**SHELDON BAKERY,
OPENSHAW,
MANCHESTER,
M11 2FB**

CULVERT DIVERSION STRATEGY

8885-HBL-XX-XX-RP-C-0010

Figure 5.1. Proposed Culvert Diversion

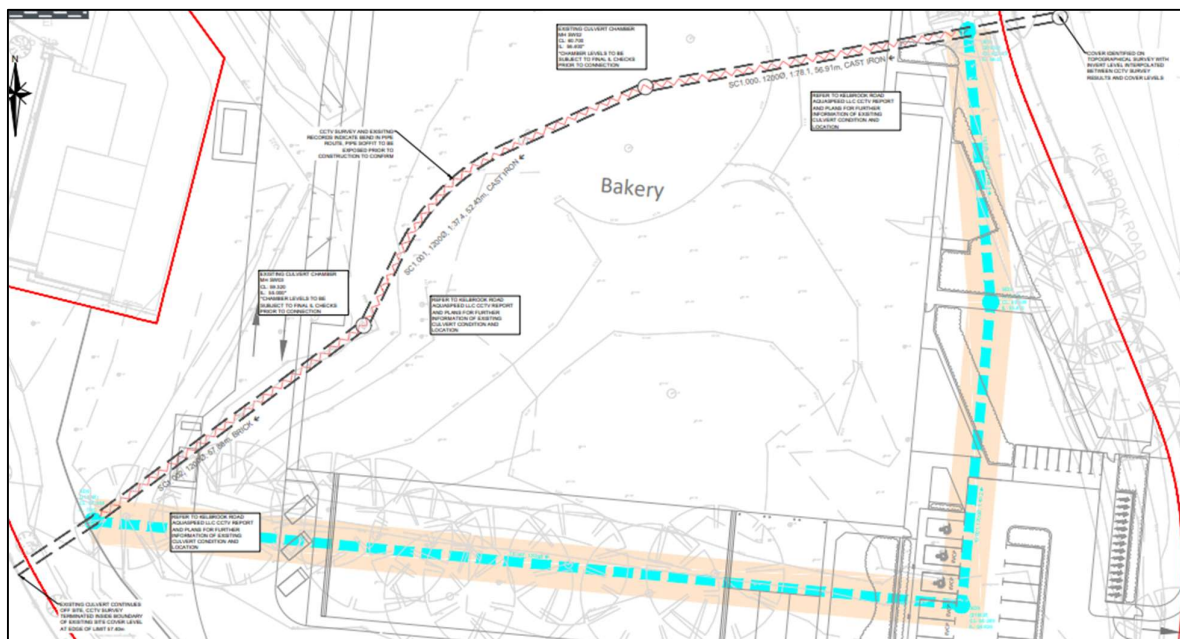
- 3.1 LLFA have commented: “Where a culverted ordinary watercourse is indicated beneath the site, further investigation is required and the development proposal should account for its presence. We recommend the LPA should uphold Policy EN 14 due to the risk of collapse and flooding associated with inappropriate development around culverted watercourses.”

- 3.2 LLFA have commented: “MCC records highlight that the underground is located within close the site while our records are frequently updated to ensure the highest level of accuracy, the records cannot guarantee 100% accuracy for all culverted assets. Therefore, we would request that the applicant informs the onsite contractor to remain observant and to take the appropriate safety precautions during excavation works. If any major unknown drainage assets are found beneath the site, then further investigation works should take place to identify the asset and MCC Lead Local Flood Authority (LLFA) should be contacted immediately. Any alterations to an ordinary watercourse will require consent from MCC LLFA under Land Drainage Act 1991.”

5.1 The diversion has been proposed to the existing culvert which is located within the site boundary. A summary of the proposed culvert chambers and pipelines can be found in Tables 5.1 and 5.2 and the proposed pipe diversion is indicated in Figure 5.1 and in Appendix 6.

- 5.2 The invert level of SD4 is currently unknown due to the invert level of SC1.002 being unknown (Section 4.6).
- 5.3 The gradient of pipe 10.002 is unknown as the invert level of SC1.002 is unknown (Section 4.6).
- 5.4 As shown on Figure 5.1, the proposed culvert diversion is all situated within the bounds of the proposed site and all proposed culvert chambers can be accessed easily.
- 5.5 Further detailed assessments will be undertaken before the commencement of construction.

- 6.1 Having reviewed the CCTV information and the existing historic records it is now deemed that the existing route and condition is known for the site.
- 6.2 As part of this it is a requirement of the future development to divert this existing culvert.
- 6.3 The proposed Culvert is detailed and will be reviewed in more detail as part of the diversion request to be made with the statutory authority. All required details for approval and construction will be provided as part of this.
- 6.4 HBL are satisfied that the documented information allows for a clear understanding of the existing culvert and it's intended diversion to enable development works to proceed.

HBL Response: As per above further investigations have now documented the details of the existing culvert route which are included. In addition to this the proposed culvert diversion route has been updated alongside presenting the abandonment of the existing culvert and levels of the new diverted route.

EXISTING CULVERTED WATERCOURSE
ROUTE

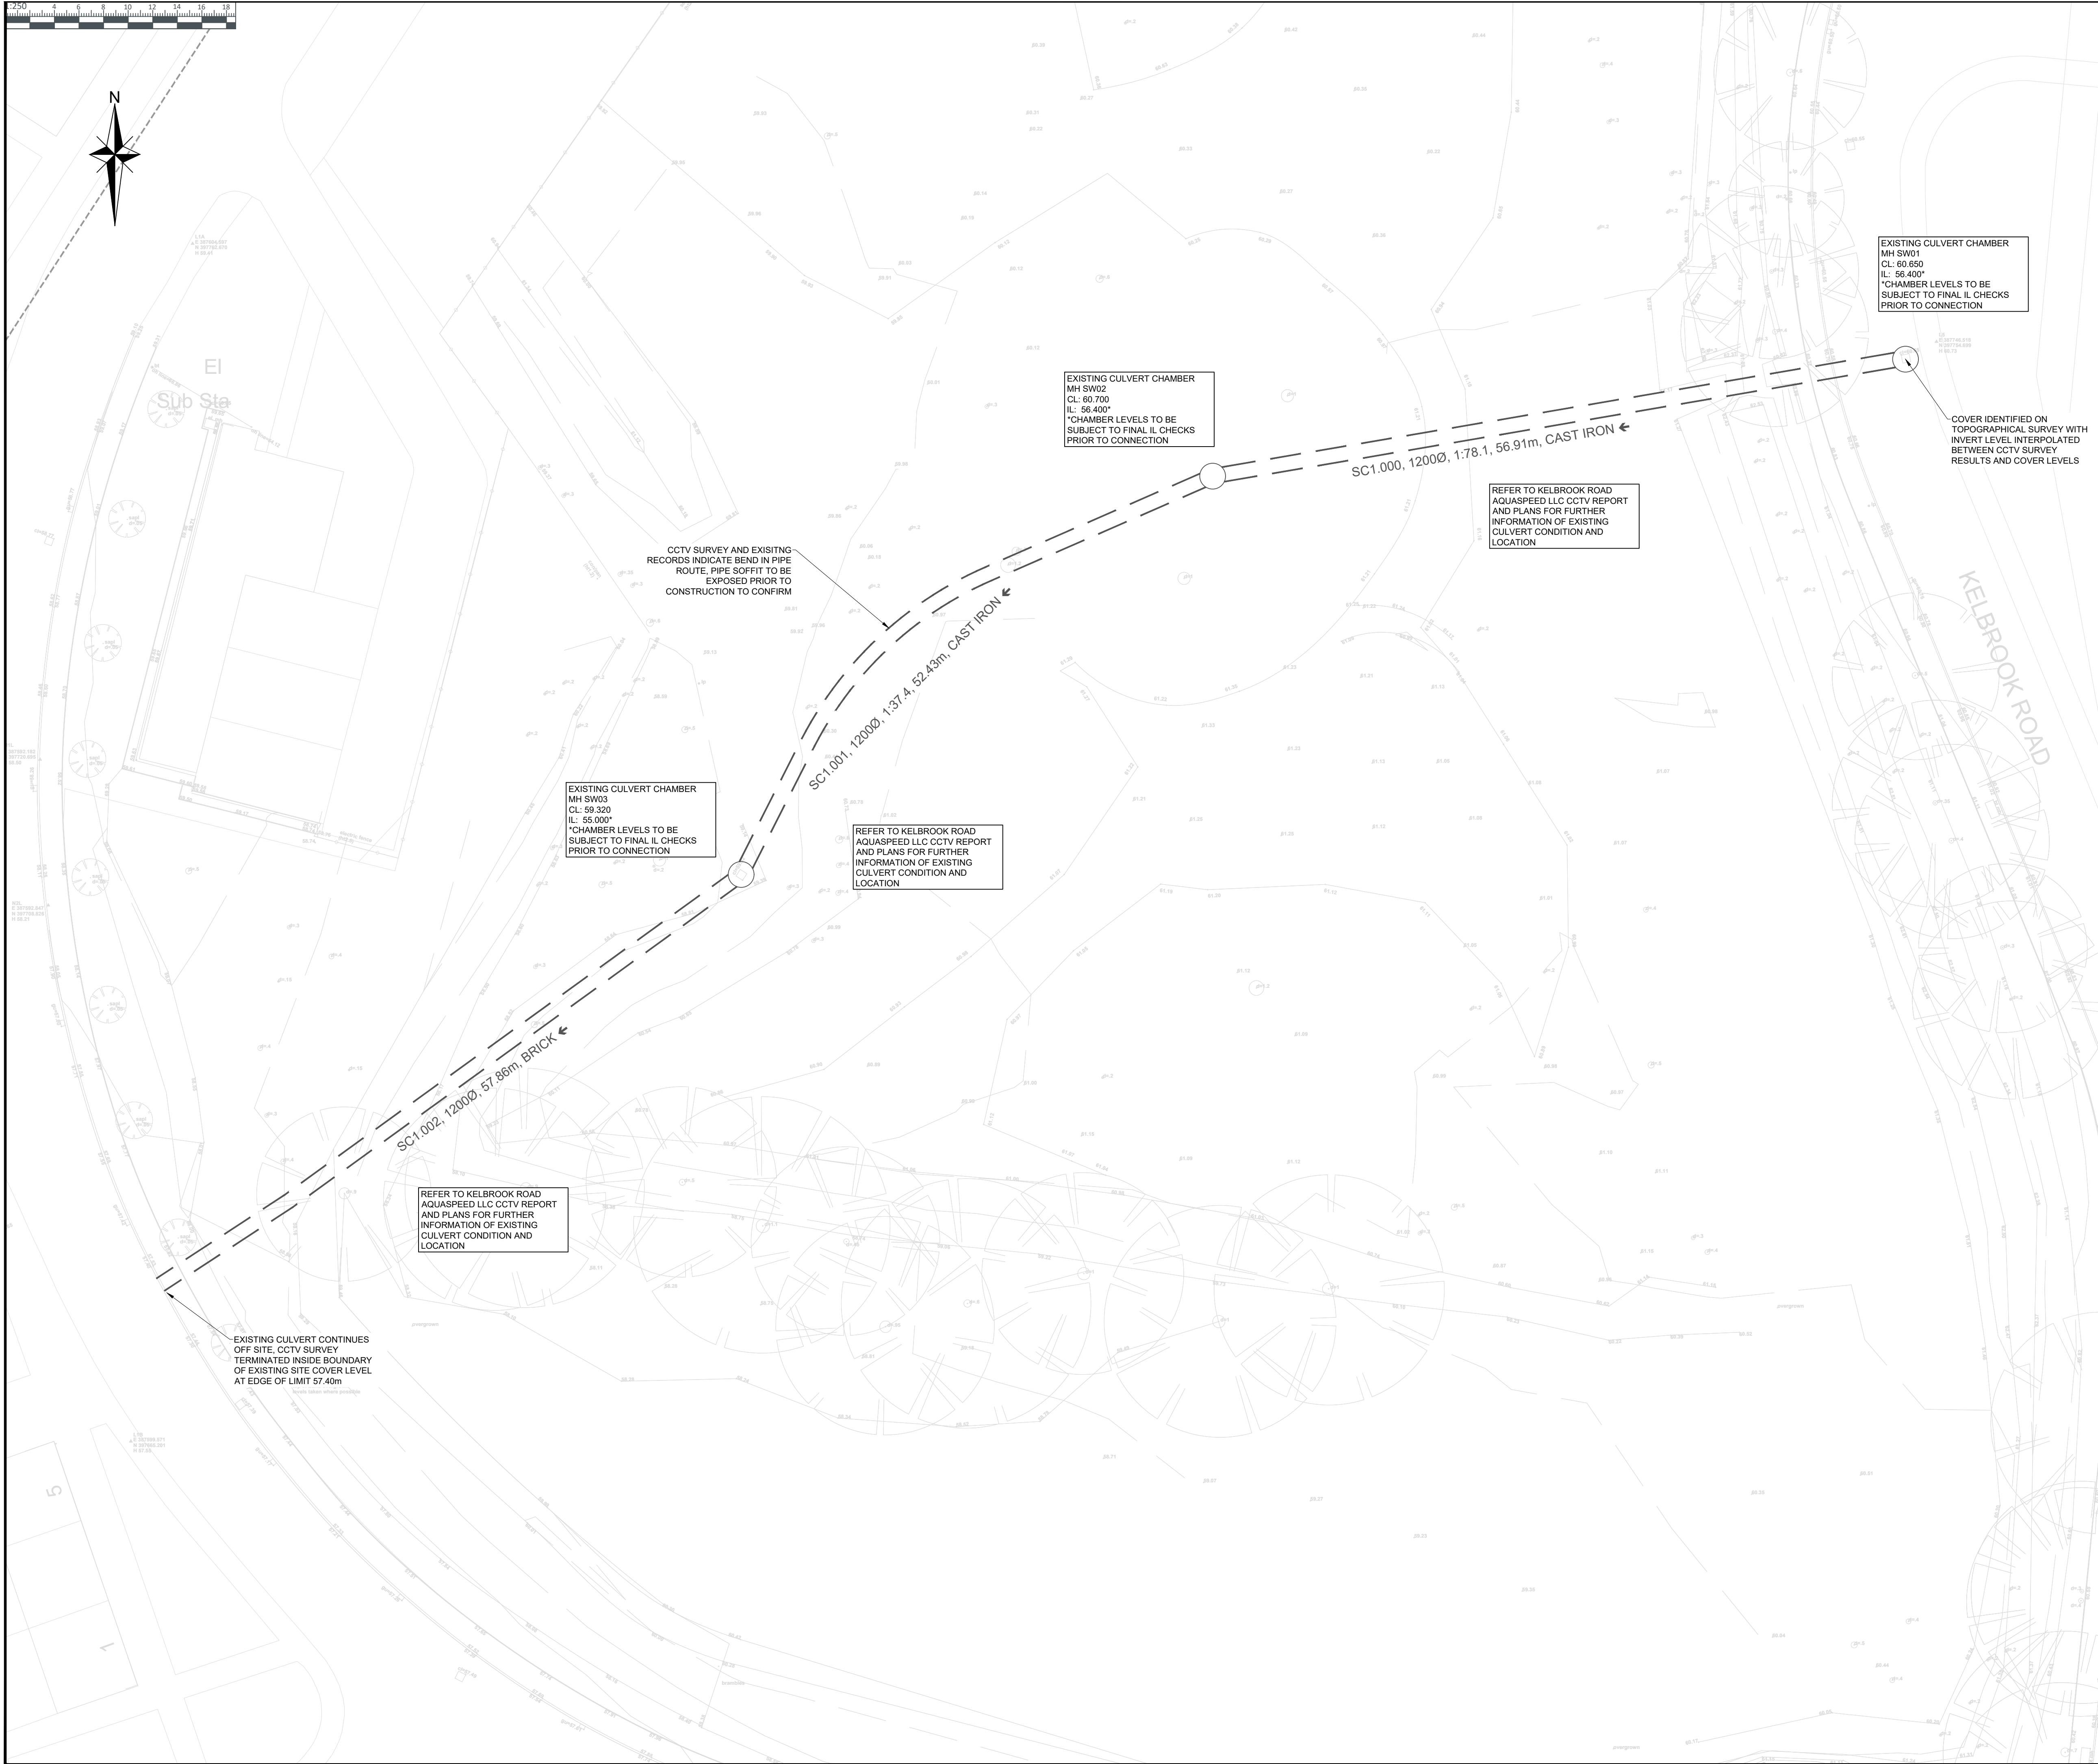
Where a culverted ordinary watercourse is indicated beneath the site, further investigation is required and the development proposal should account for its presence. We recommend the LPA should uphold Policy EN 14 due to the risk of collapse and flooding associated with inappropriate development around culverted watercourses.

HBL Response: Following further investigations including a full CCTV survey, the route, size, condition and initial levels of the exiting culvert have been documented across the plans and CCTV survey report/videos.
